**ADDENDUM NO. 1**  
**2025 ASPHALT OVERLAY PROJECT**  
**PROJECT #12525**

**ATTENTION ALL BIDDERS AND PLANHOLDERS:** You are hereby notified that the Bid and Contract Documents are amended as follows:

2025 ASPHALT OVERLAY

SHT. 65

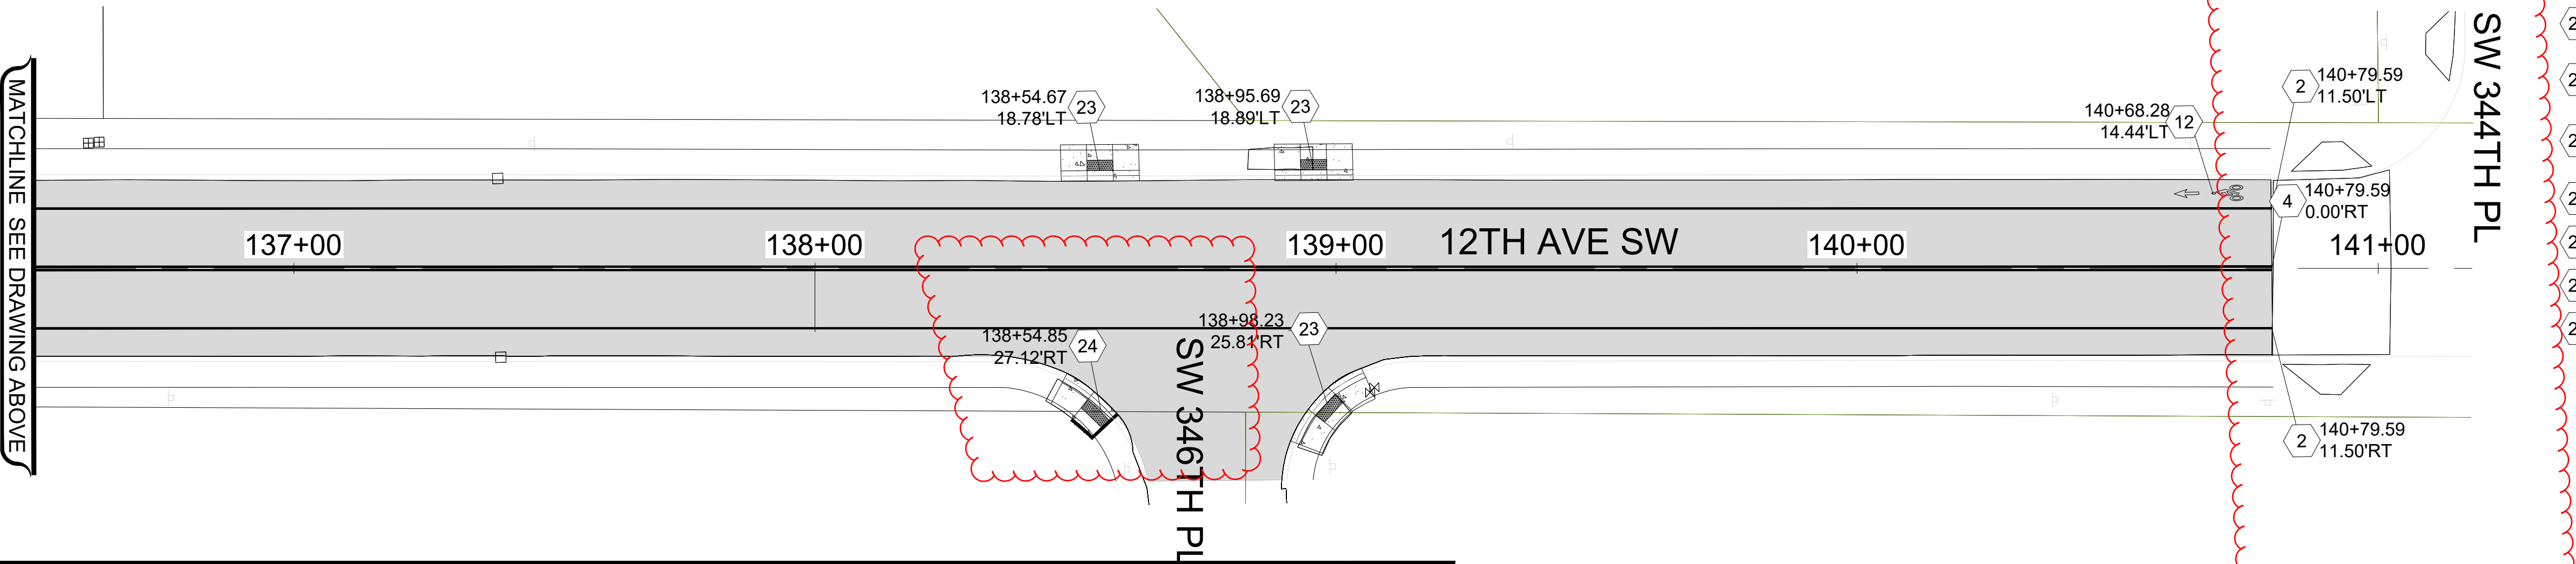
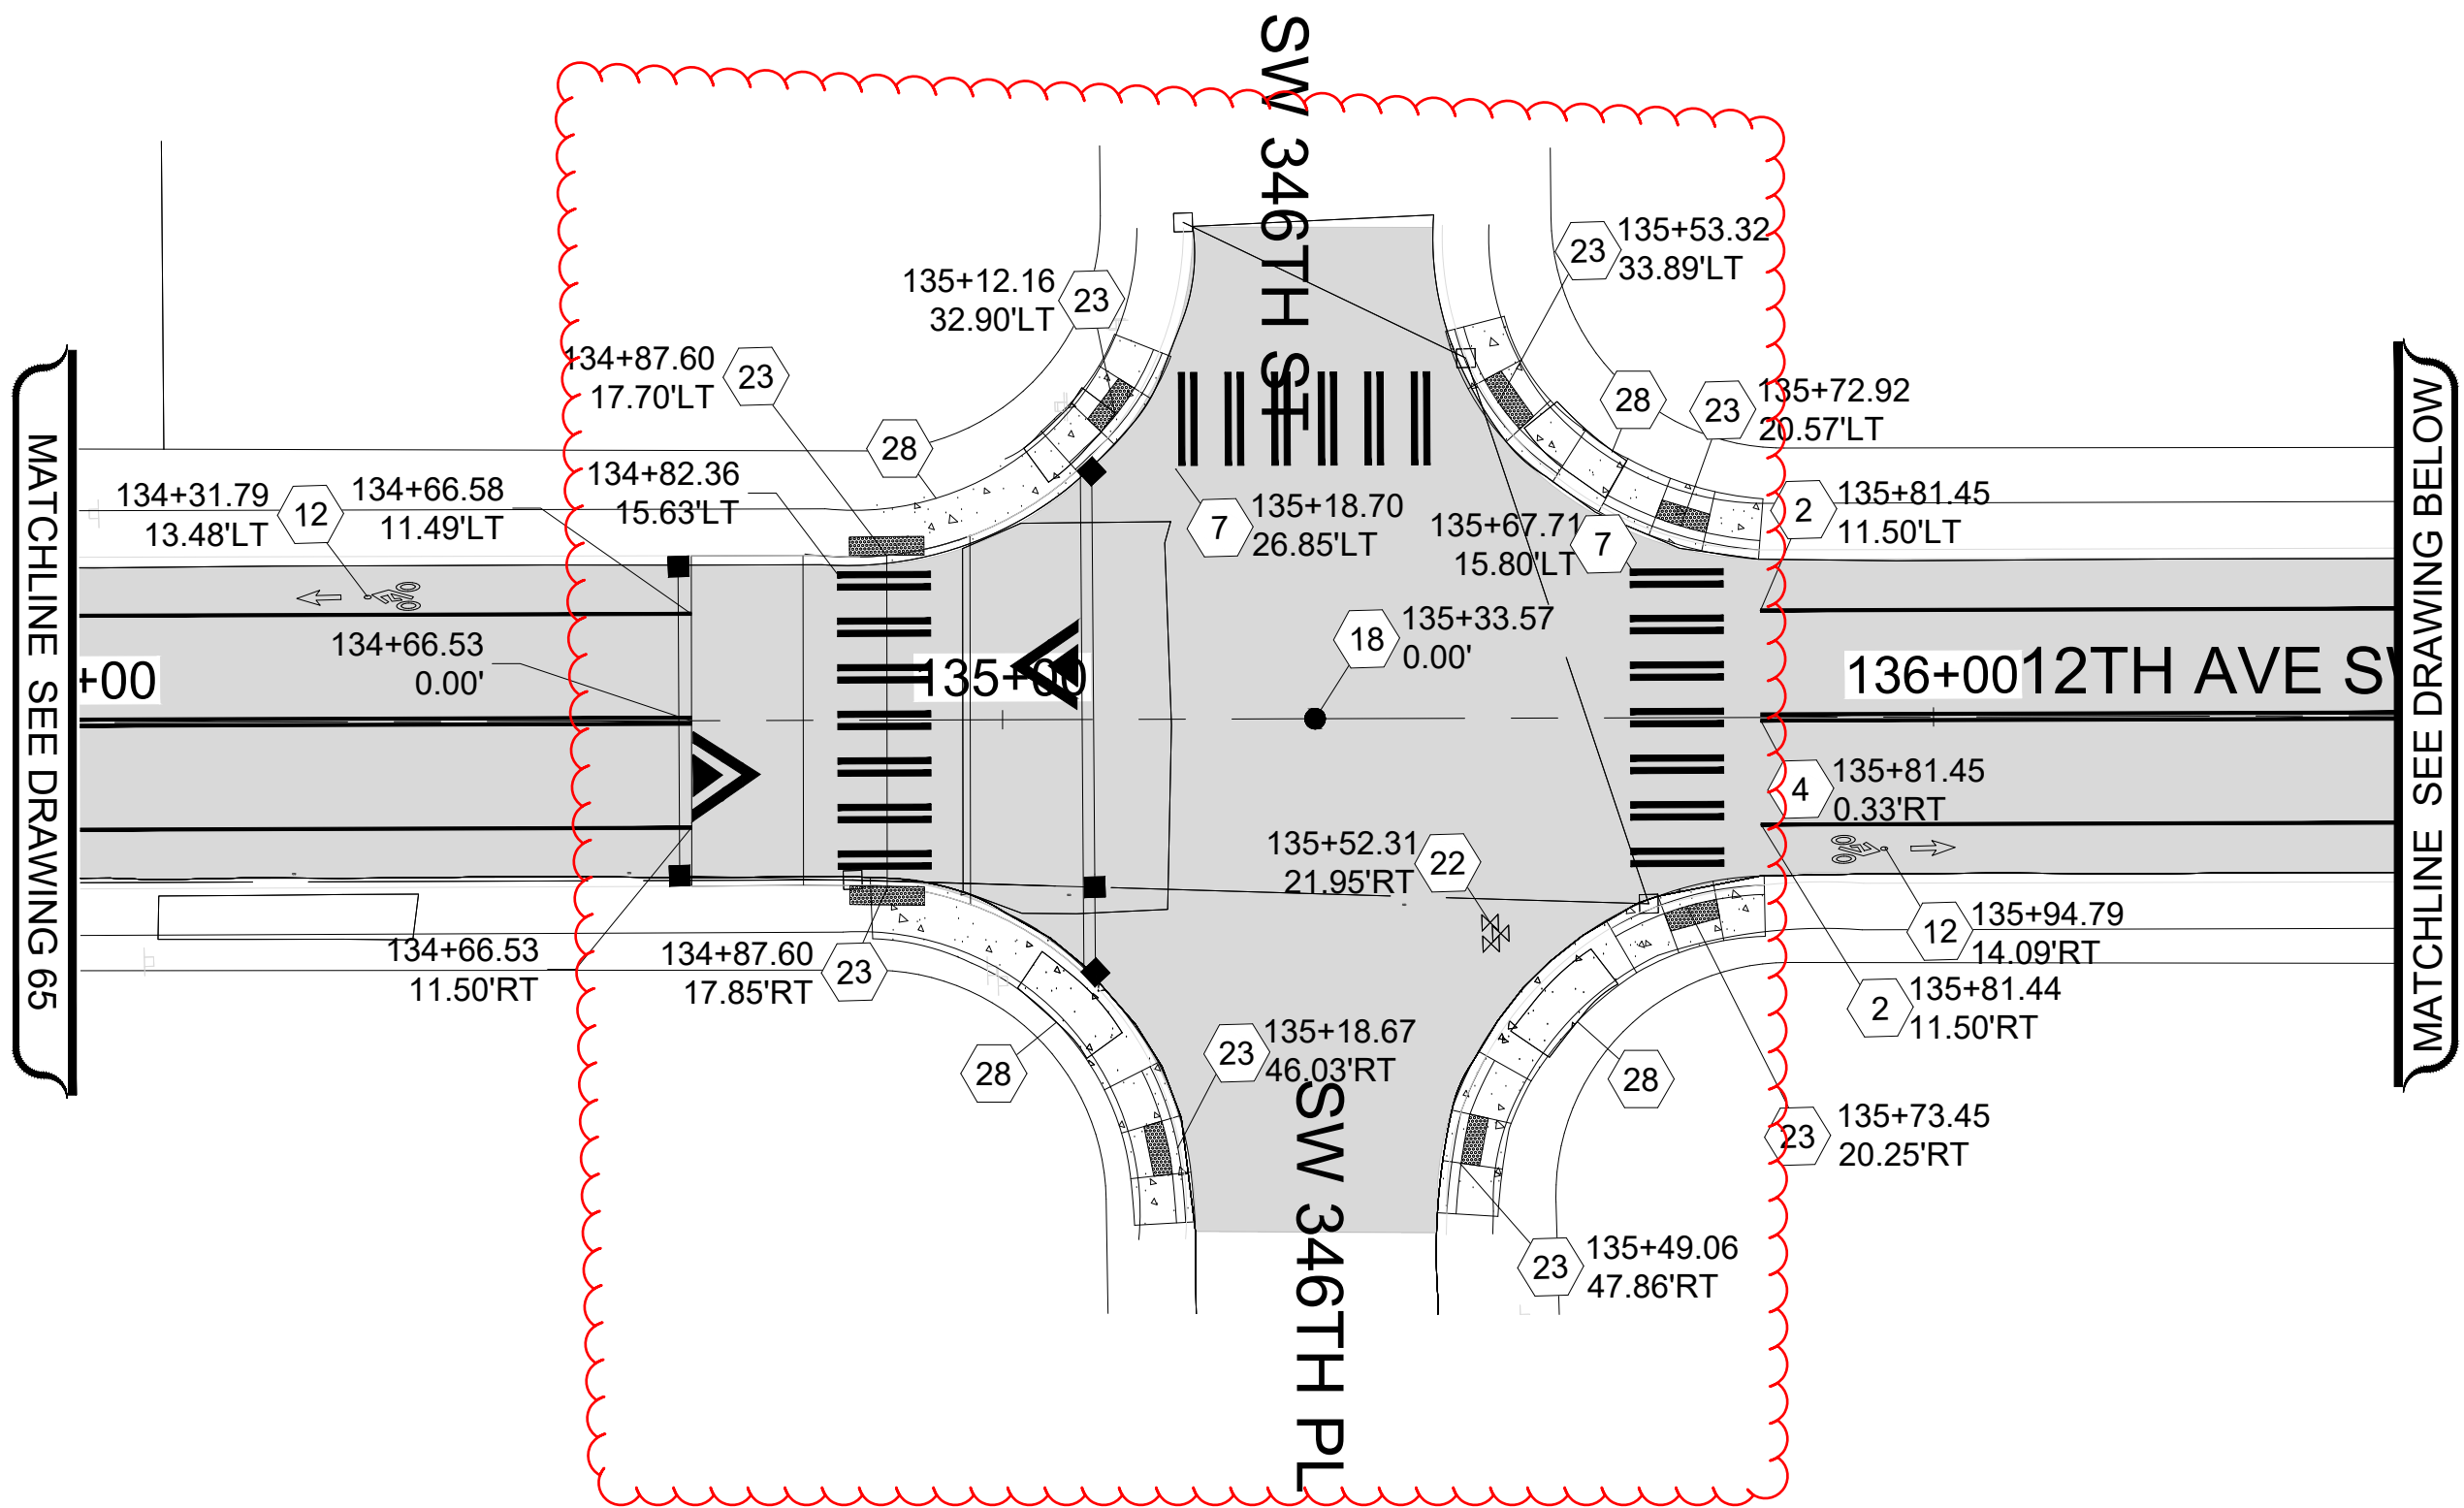
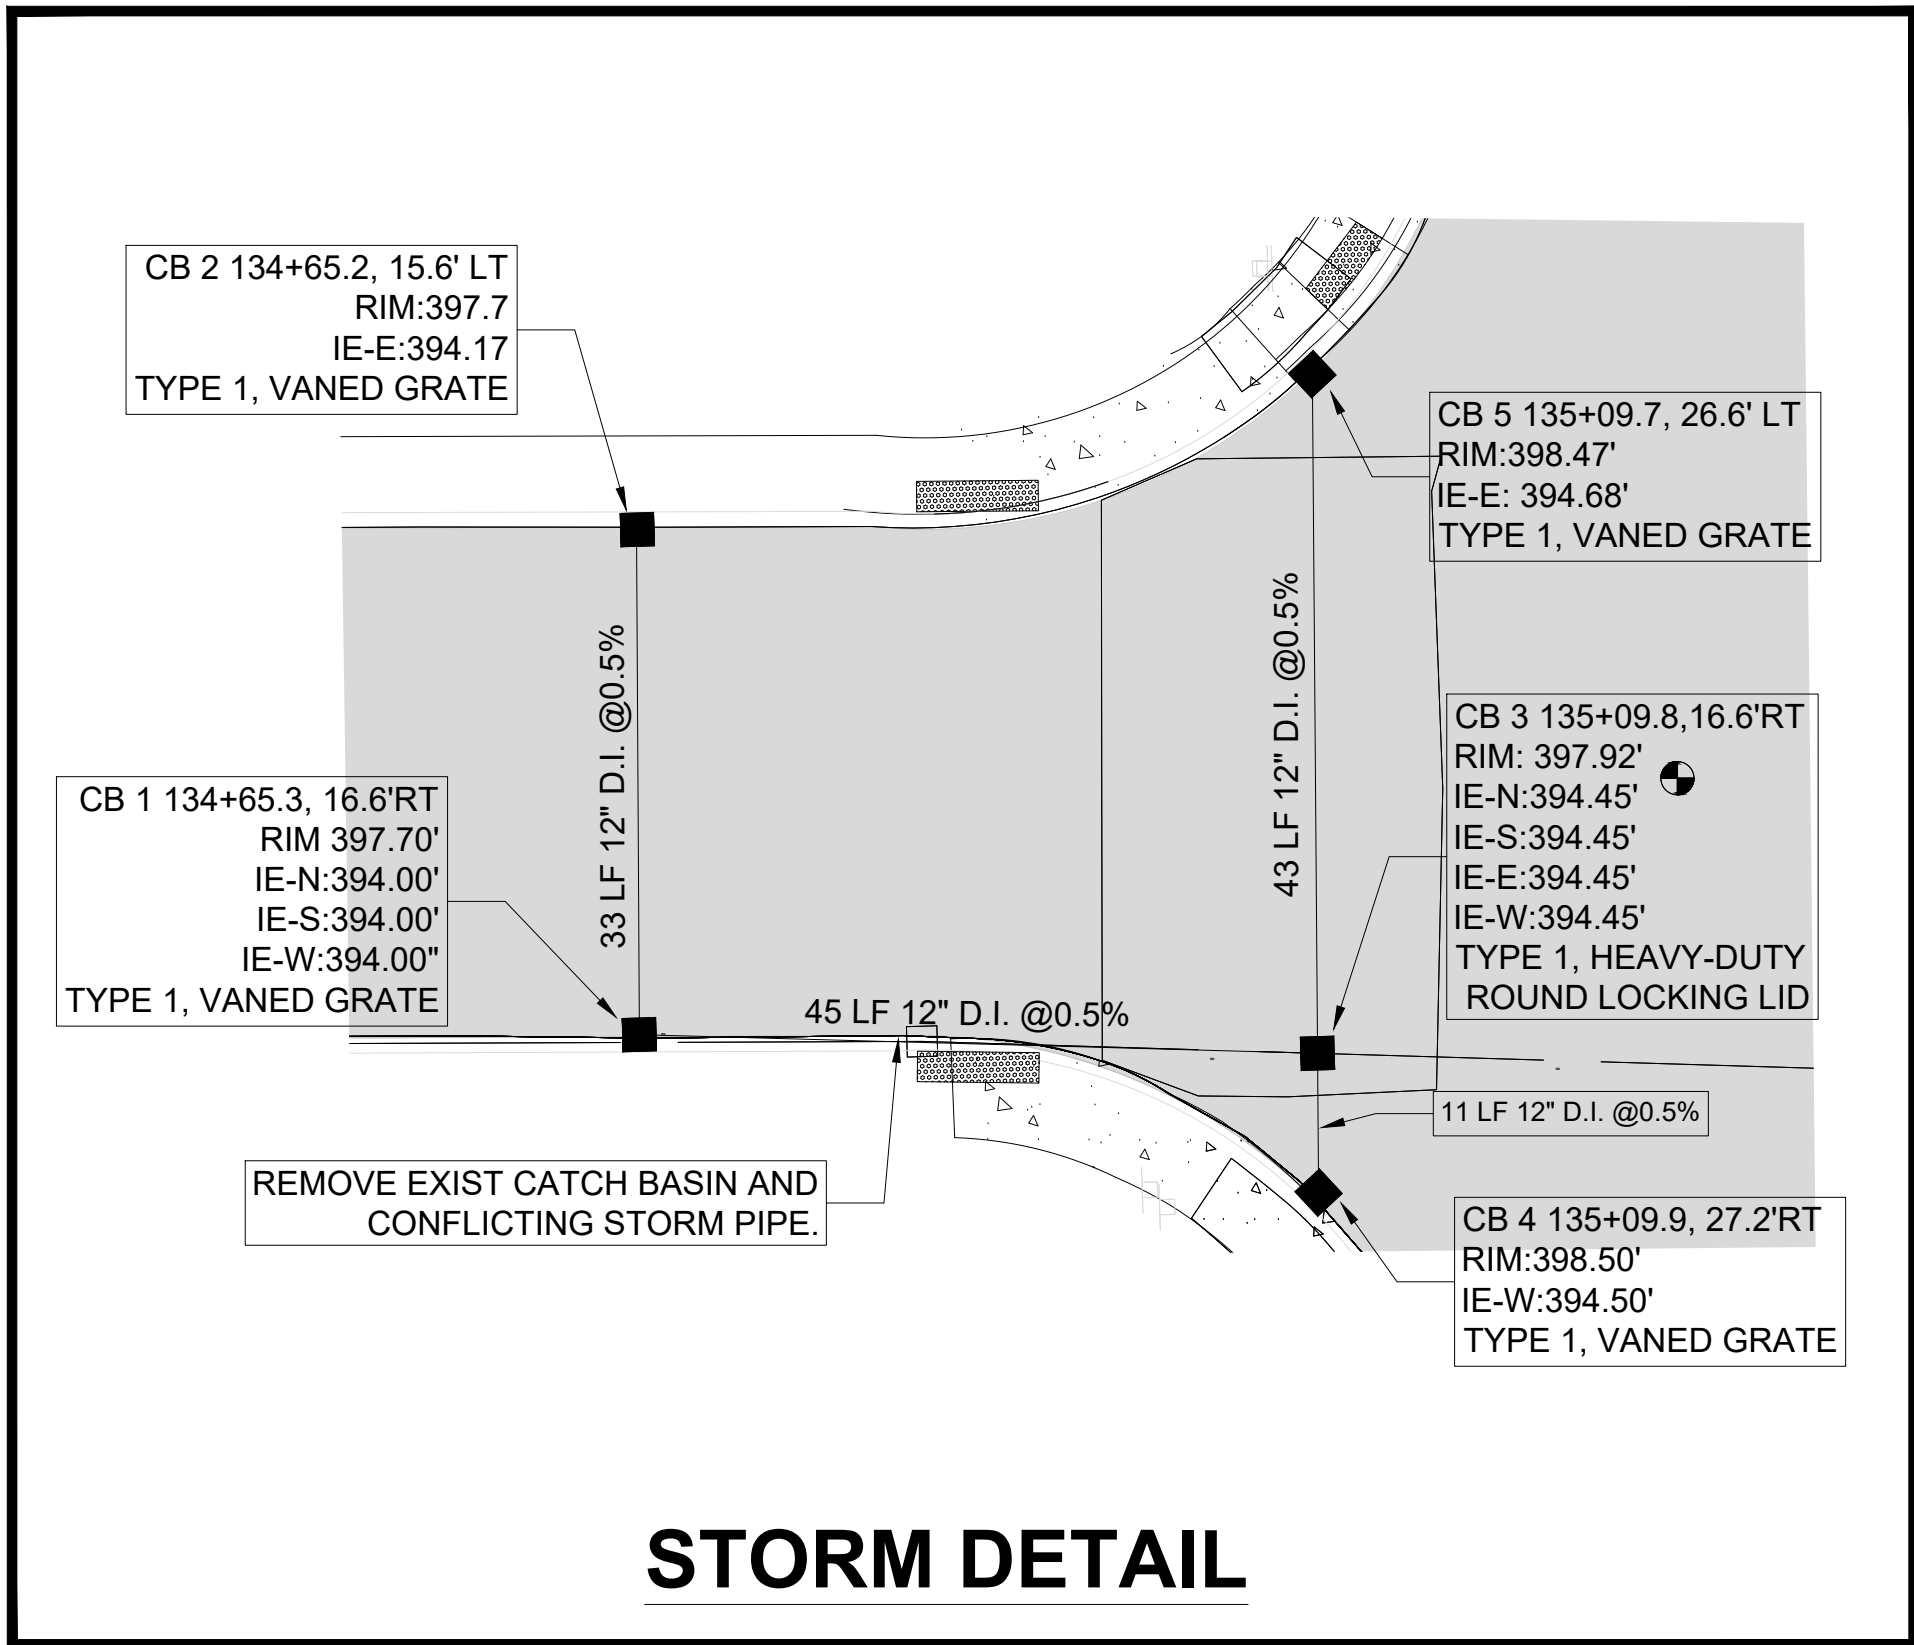
### **(4) Sheets 63-66 of 125 Plan Set:**

- Added Cement Conc Sidewalk Callouts
